Subject: **Response to On Hold Letter** for request for Section 401 Water Quality Certification Modification, Wilmington Bypass from north of US 74/76 in Brunswick County to US 421 in New Hanover County. DWQ Project No. 10-0867v.4. TIP R-2633B.

Reference: NCDOT Modification Request, dated April 3, 2013
NCDWQ On Hold Letter, dated April 19, 2013, received April 26, 2013

Subject: Request for Modification to Individual Section 404 and Section 401 Water Quality Certification for the Wilmington Bypass from north of US 74/76 in Brunswick County to US 421 in New Hanover County. Federal Aid Project Nos. NHF-0017 (96) and STM-0017(97), WBS No. 34491.2.3, TIP No. R-2633B, DWQ Project No. 10-0867v.4

WETLAND CROSS SECTION
SITE 6

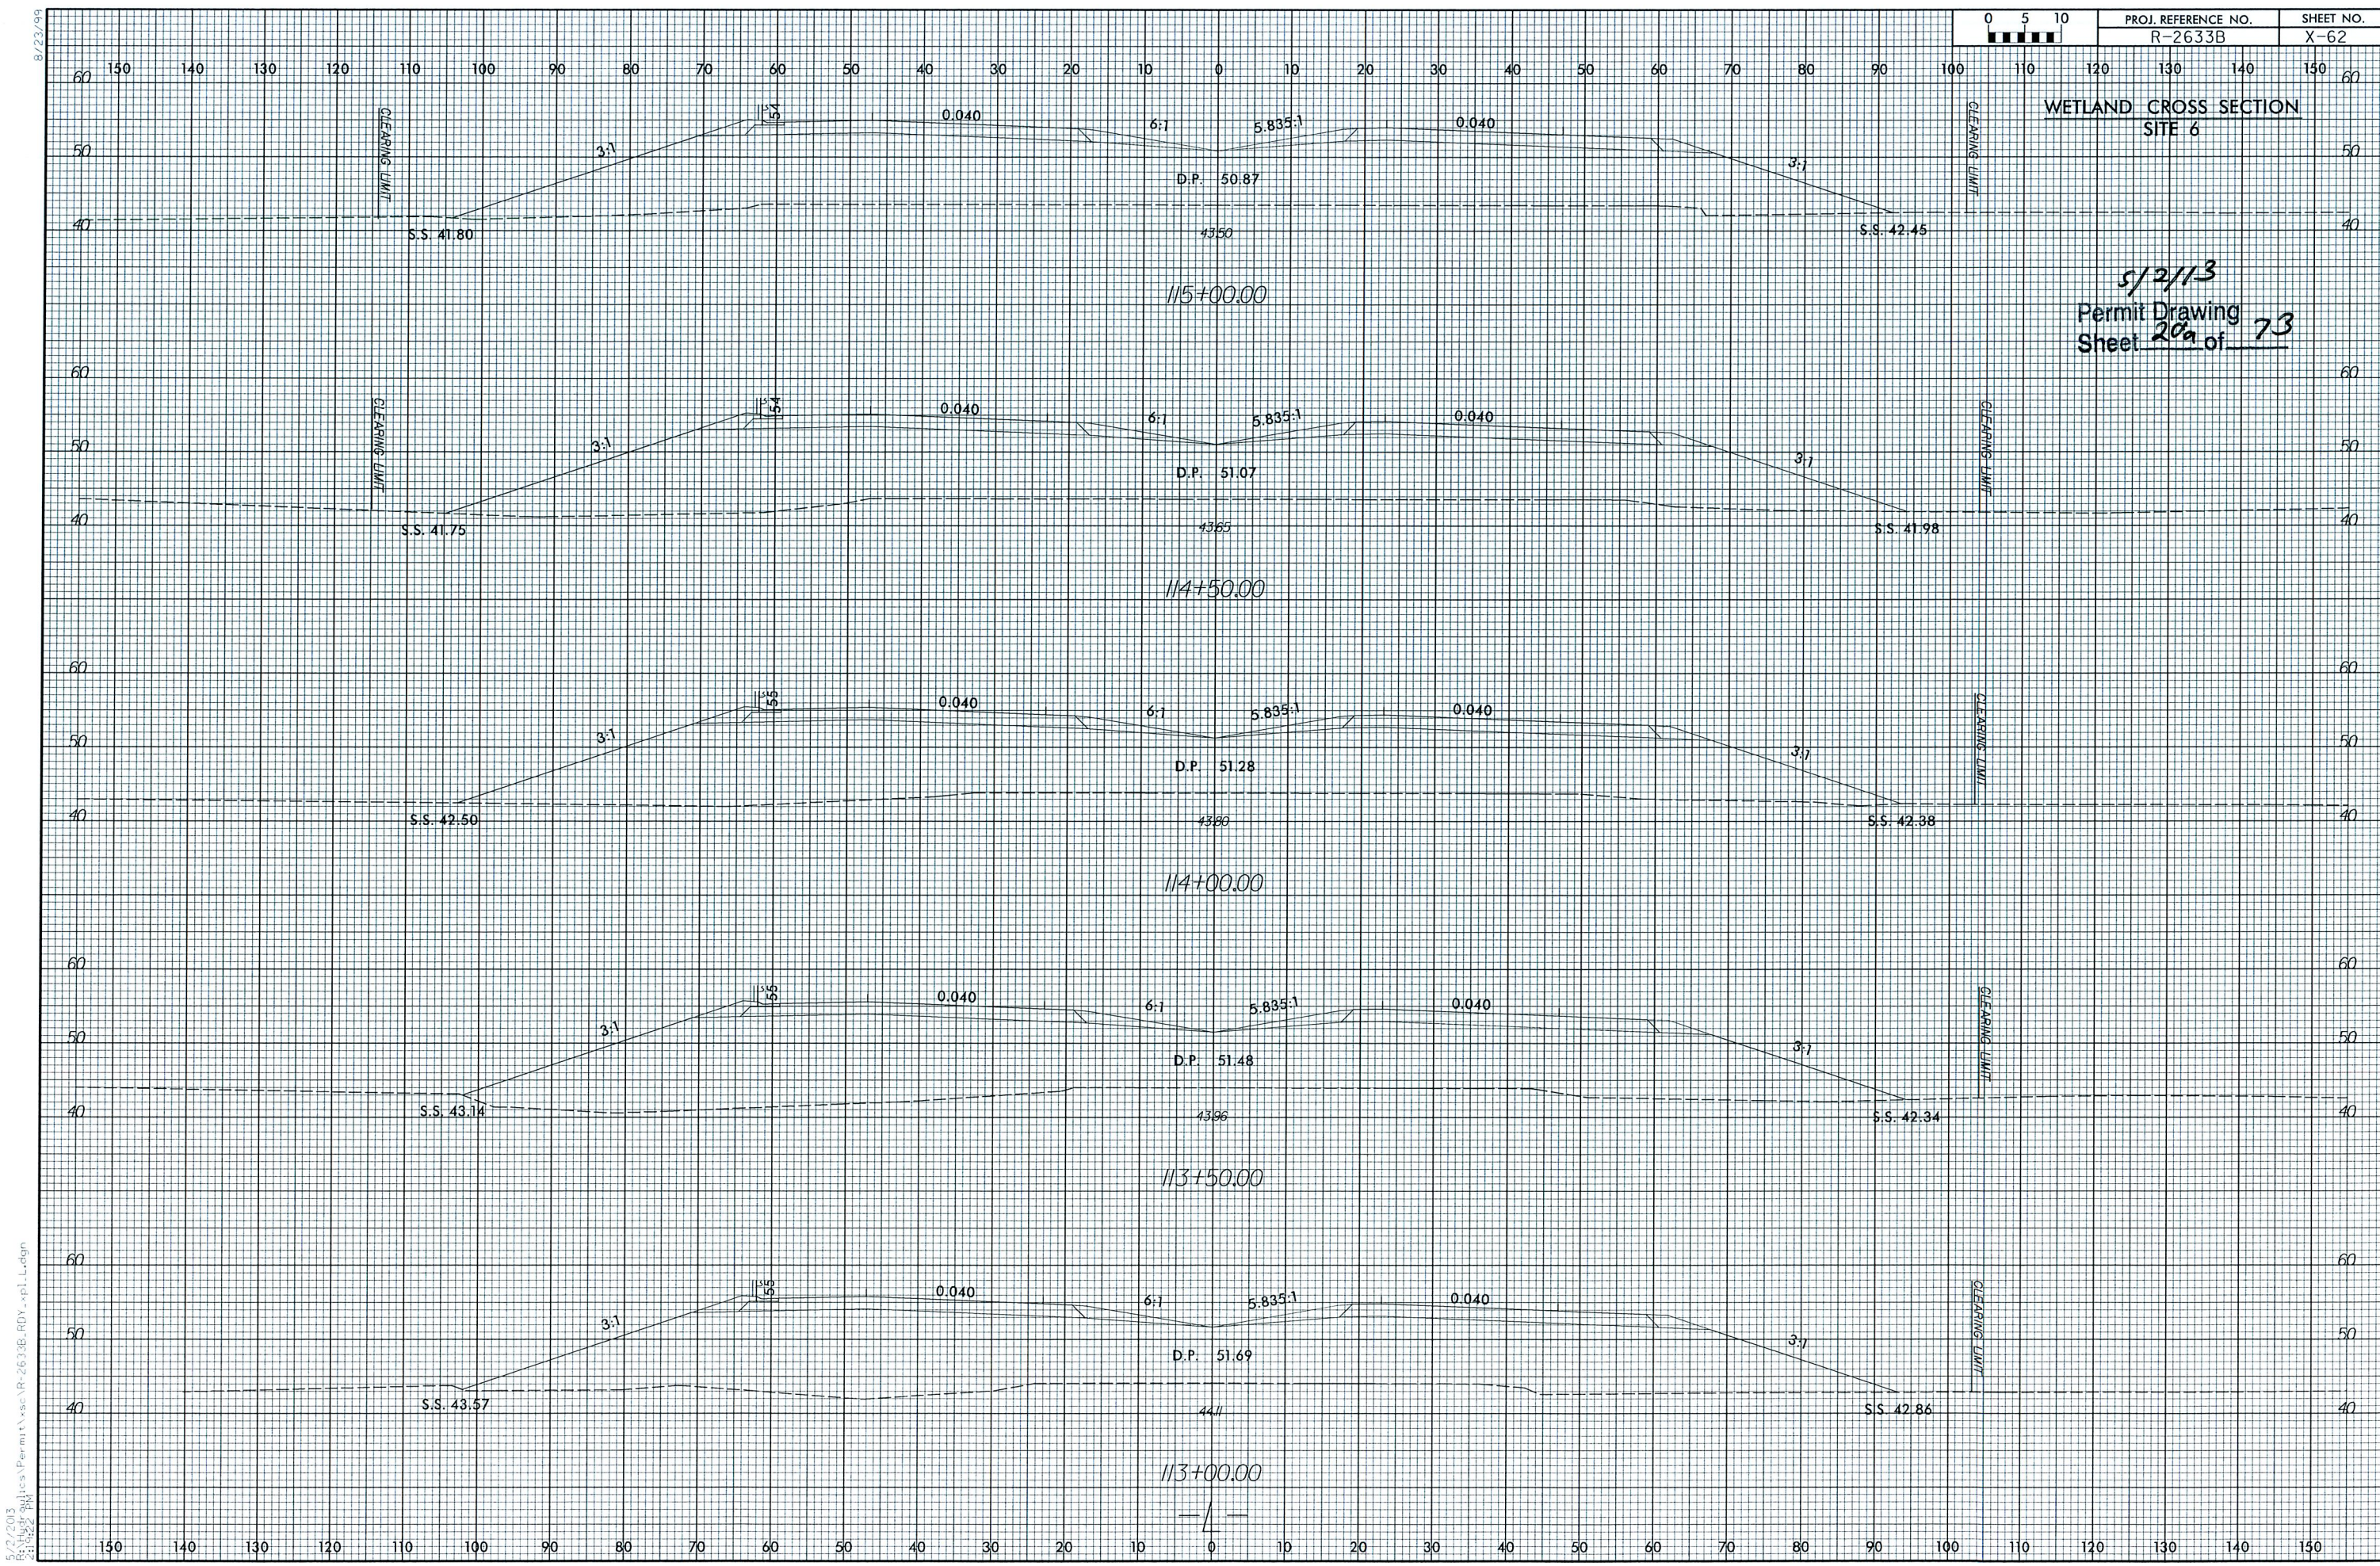
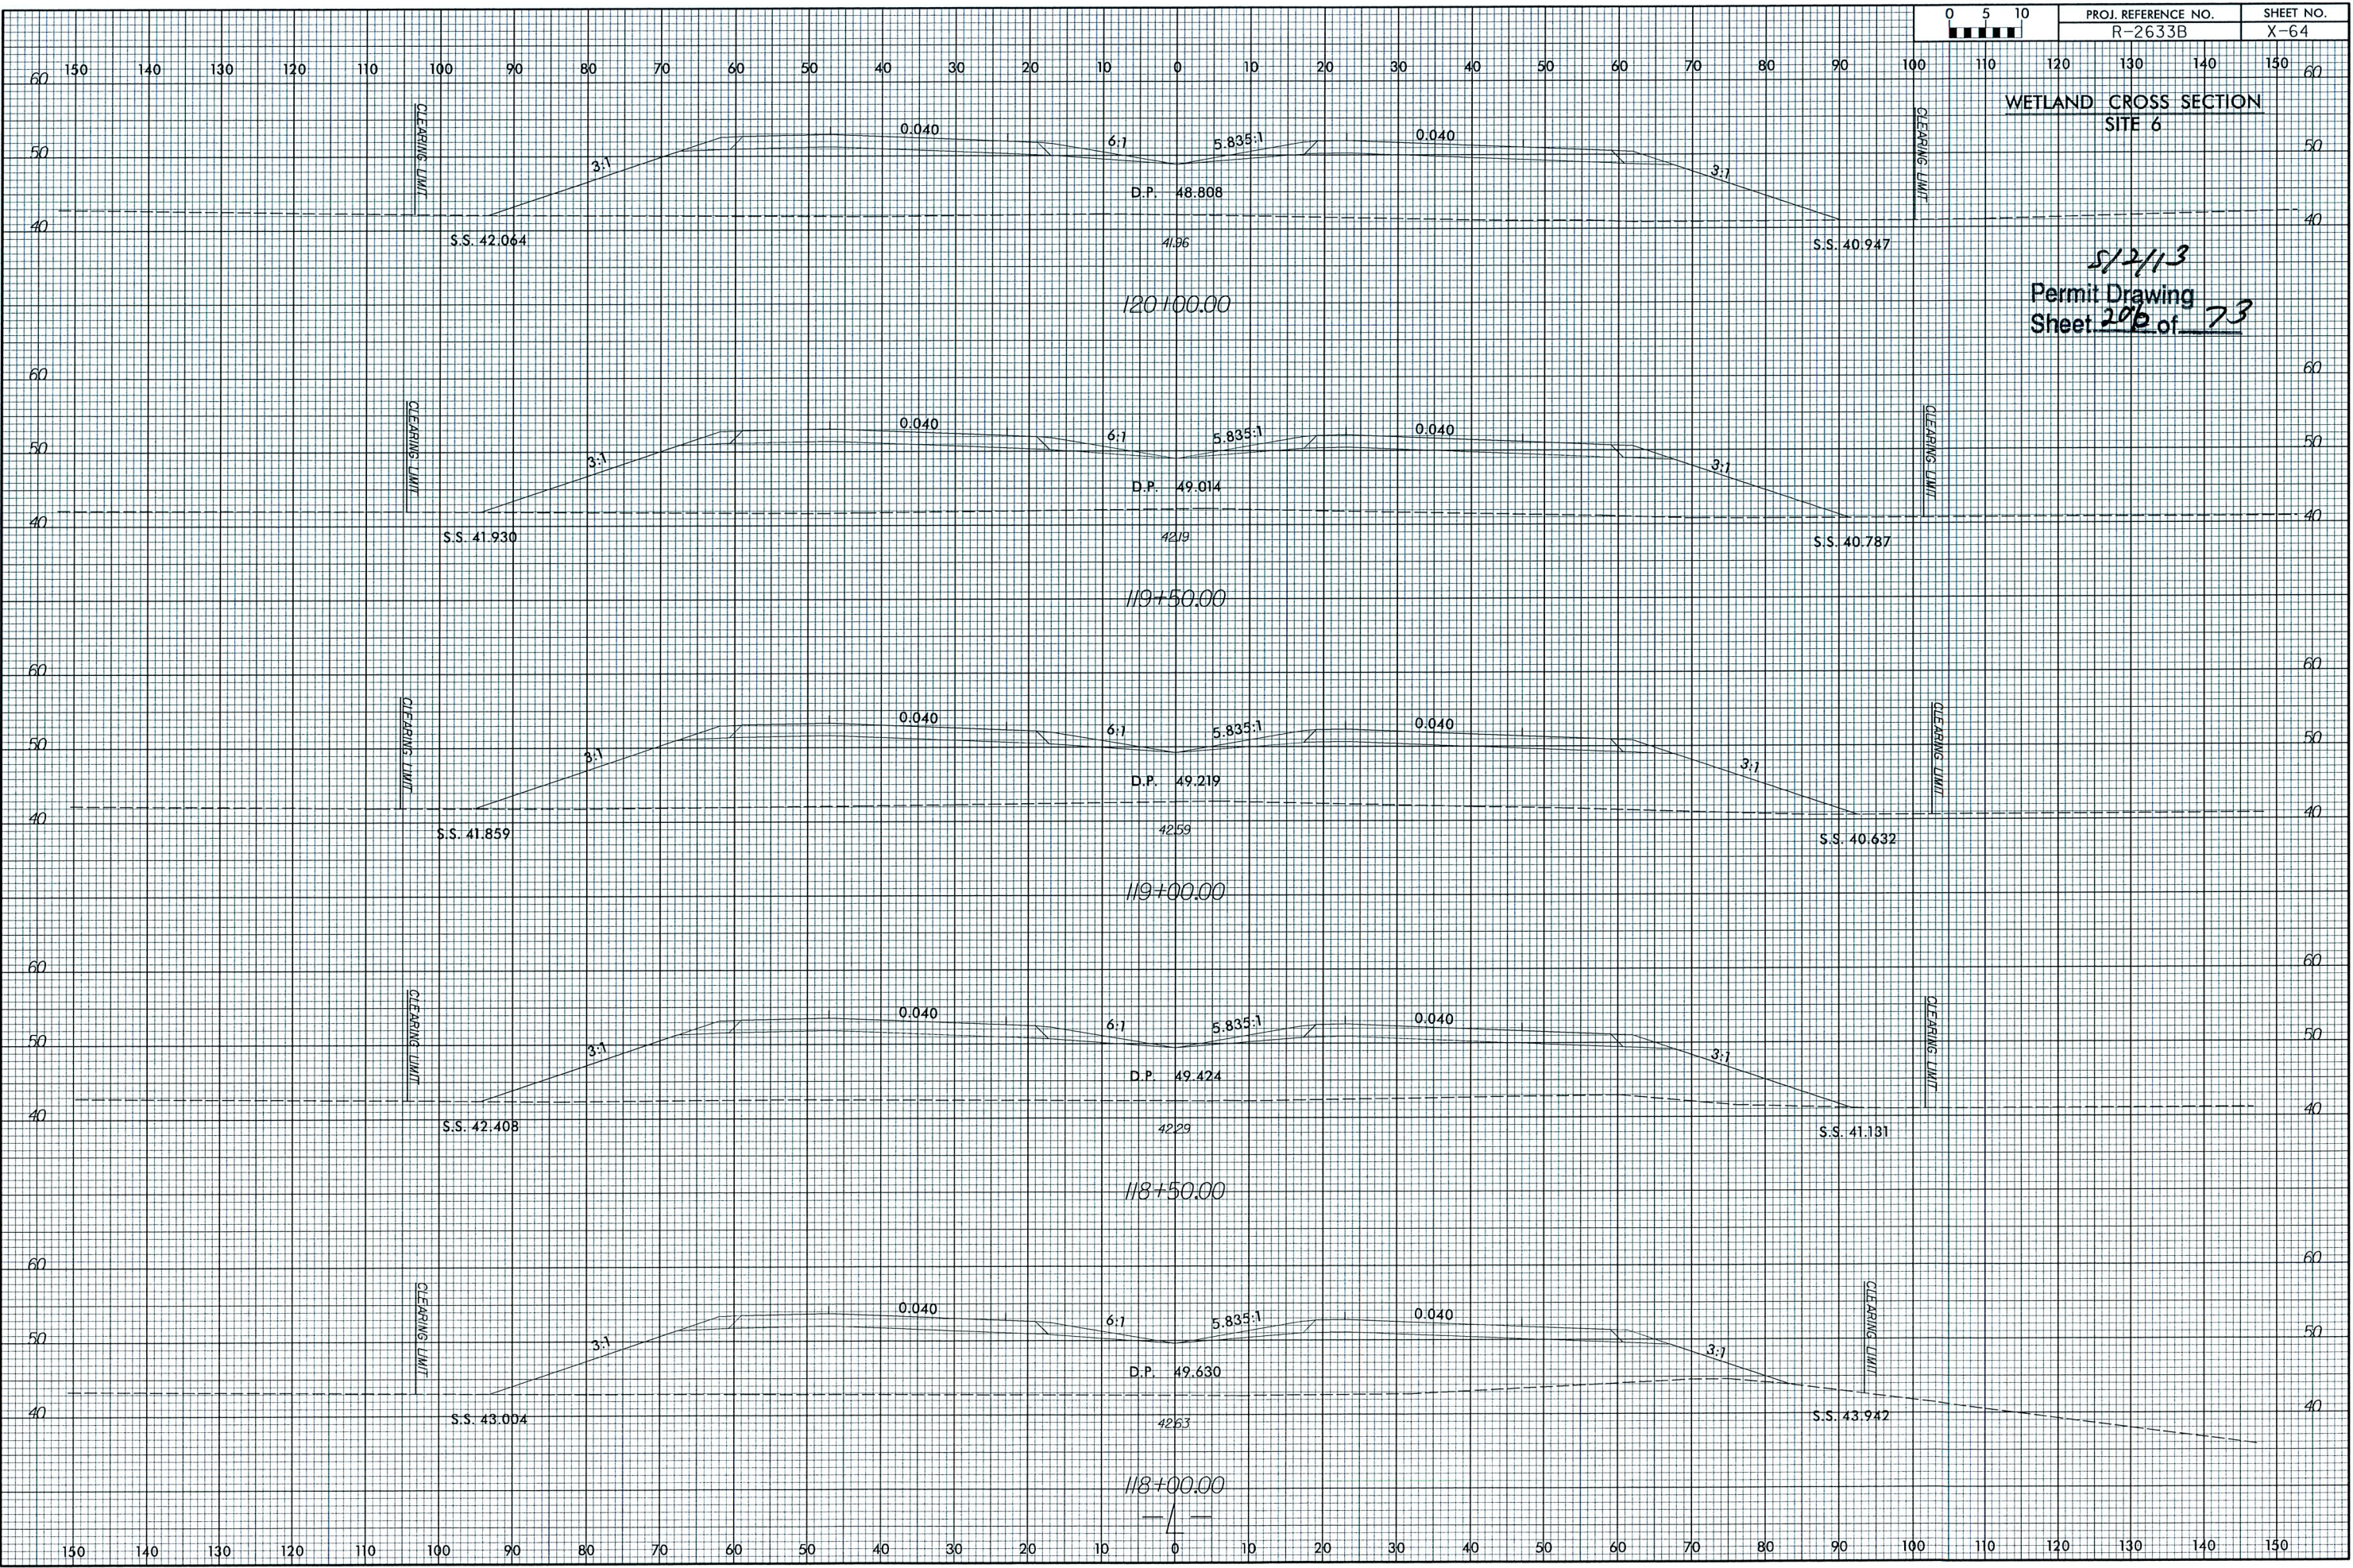
2. *Site 6 – no cross sections were provided for the wetland impacts between Sta. 109+28 to 118+00 and 123+00 to 135+00. Please provide these cross sections.*

2. Site 6 – no cross sections were provided for the wetland impacts between Sta. 109+28 to 118+00 and 123+00 to 135+00. Please provide these cross sections.

3. Your application states in the "Avoidance and Minimization" section that 3:1 slopes will be used in wetland areas to minimize wetland impacts. Upon review of the application there are several cross sections that show greater than 3:1 slopes. Please correct.

Representative cross sections were provided in the application. Nevertheless, additional cross sections are enclosed, providing a larger sampling of cross sections in jurisdictional areas.

Sites 3, 5 & 6 permit drawings, cross sections, and impact summary sheet have been revised and are enclosed. As a result, proposed permanent fill has decreased at these sites by 1.42 acres. Additionally, we will submit a revised request to EEP for an updated acceptance letter.
